RESPONSES TO CEC COMMENTS ON THE
MODELING PROTOCOL SUPPLEMENT FOR
THE HYDROGEN ENERGY CALIFORNIA
(HECA) PROJECT

Revised Application for Certification (08-AFC-8)

Responses to CEC Comments on February 21, 2012 Modeling Protocol Supplement

Technical Area: Air Quality

ATTACHMENT 4-1

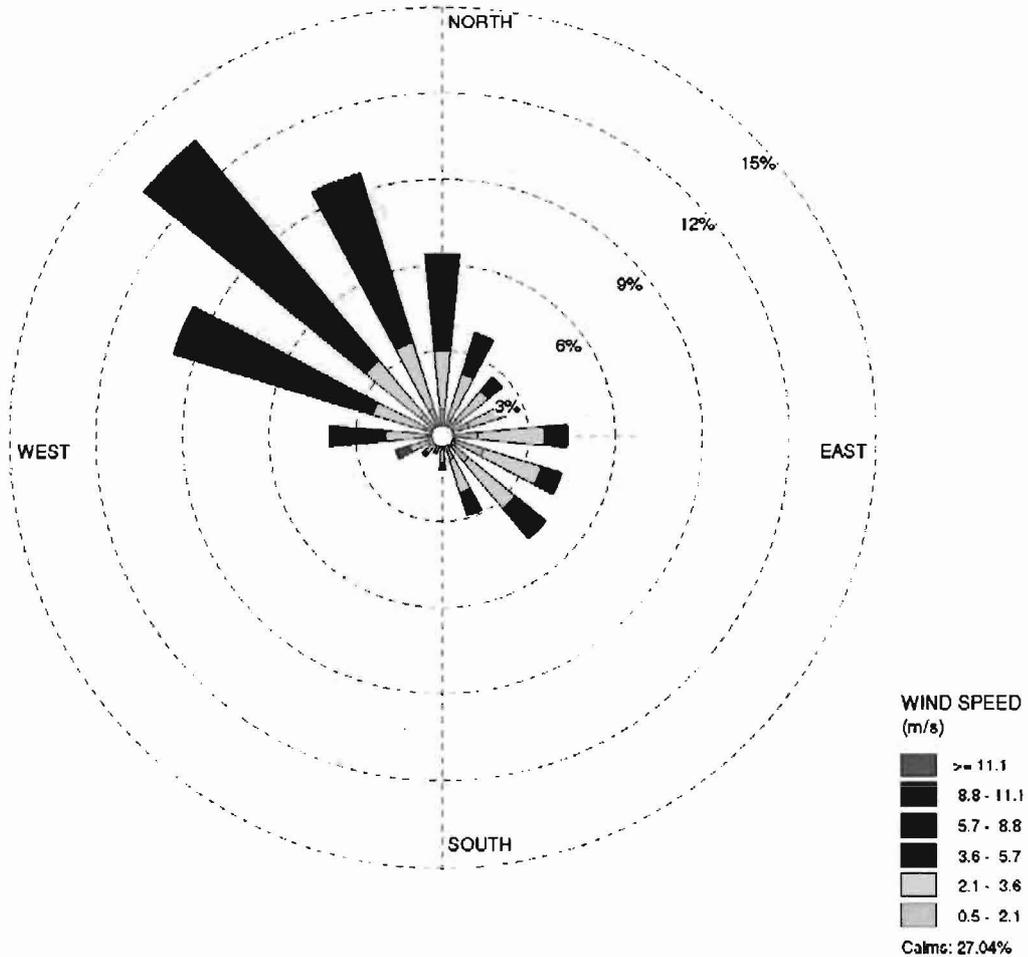
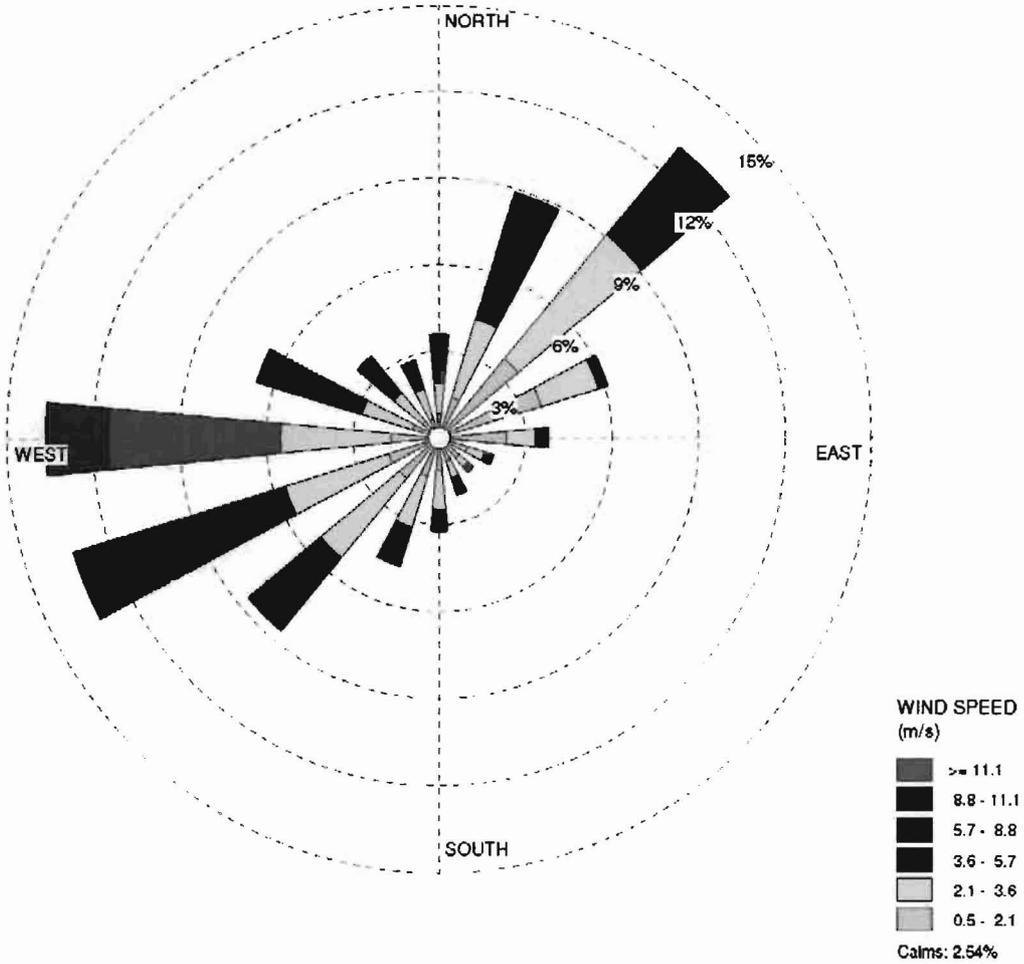
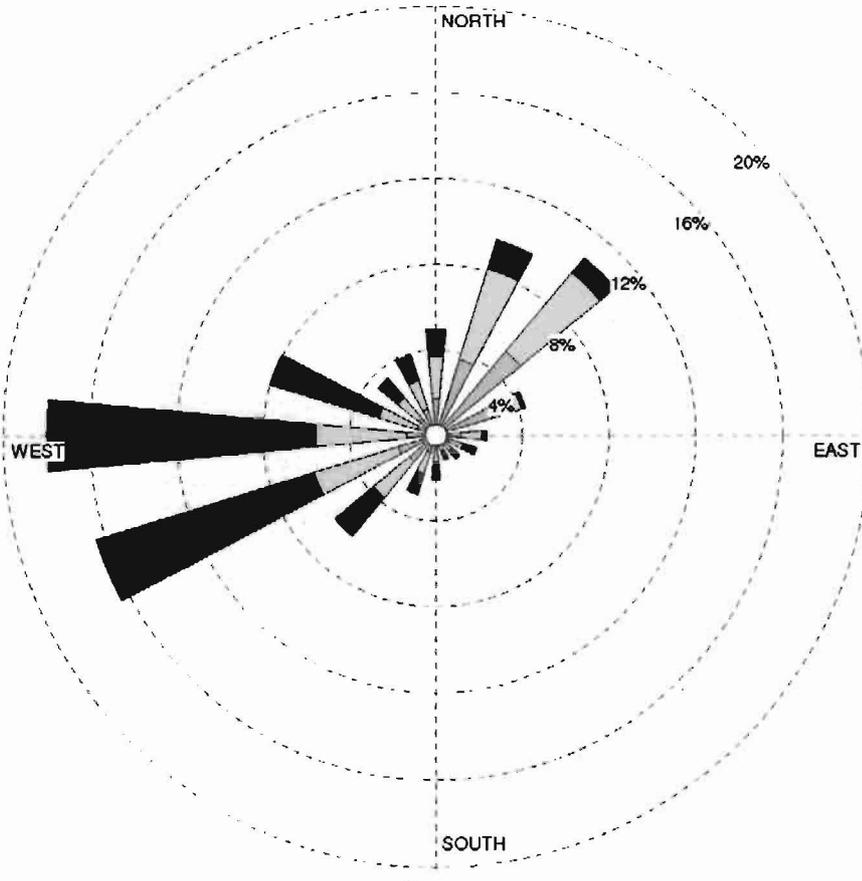
4. ***Page 9 – Meteorological data selection. It is understood given SJVAPCD modeling guidance why the Bakersfield meteorological data was selected for the criteria pollutant modeling analysis, but there is MM5 derived meteorological data from the west side of air basin that could be used for the HRA modeling. Please discuss why this data isn't being used and identify if SJVAPCD was consulted about the use of this data for the HRA and the results of that consultation.***

SJVAPCD was consulted, and they provided meteorological data to be used for all dispersion modeling analyses using the American Meteorological Society/Environmental Protection Agency Regulatory Model (AERMOD), including both Ambient Air Quality Standards and Health Risk Assessment (HRA) modeling. SJVAPCD processed and provided to HECA the data from the most representative meteorological station, the Bakersfield airport, for the five most recent available meteorological years. HRA modeling will use AERMOD and Hotspots Analysis and Reporting Program (HARP) On-Ramp with the same meteorological data set used for the criteria pollutant modeling analyses for consistency with the analyses that will be conducted by SJVAPCD in review of the air permit. SJVAPCD has provided hourly meteorological data that pair in time with the hourly background ozone and nitrogen dioxide data for 2006–2010. This is the most recent 5-year data set available for all parameters needed. HECA will be using these years of data for all modeling analyses.

To determine the most representative meteorological station, SJVAPCD and HECA considered many factors. The HECA Project is situated in a valley at a base elevation of 87 meters. The Bakersfield airport station is 20 miles away and is also situated in the valley, with an elevation of 149 meters. However, sites on the west side of the air basin that use the MM5 data for the basis of the data set are at Missouri Triangle and Fellows, both upslope in the hills west of the HECA Project Site, at base elevations of 268 meters and 472 meters, respectively. Temperatures would generally be cooler in the hills, and wind patterns are not as representative at these stations as at the Bakersfield airport station, which is situated in the valley, as is the HECA Project Site.

Attachment 4-1 presents wind roses for a comparison of wind speed and direction at Bakersfield Meadows Field Airport, Fellows, and Missouri Triangle stations for the most recent 5-year periods at each site. The wind directional patterns differ more in the valley than in the hills; therefore, the most representative meteorological data from the Bakersfield station will be used for the criteria pollutant and HRA modeling.
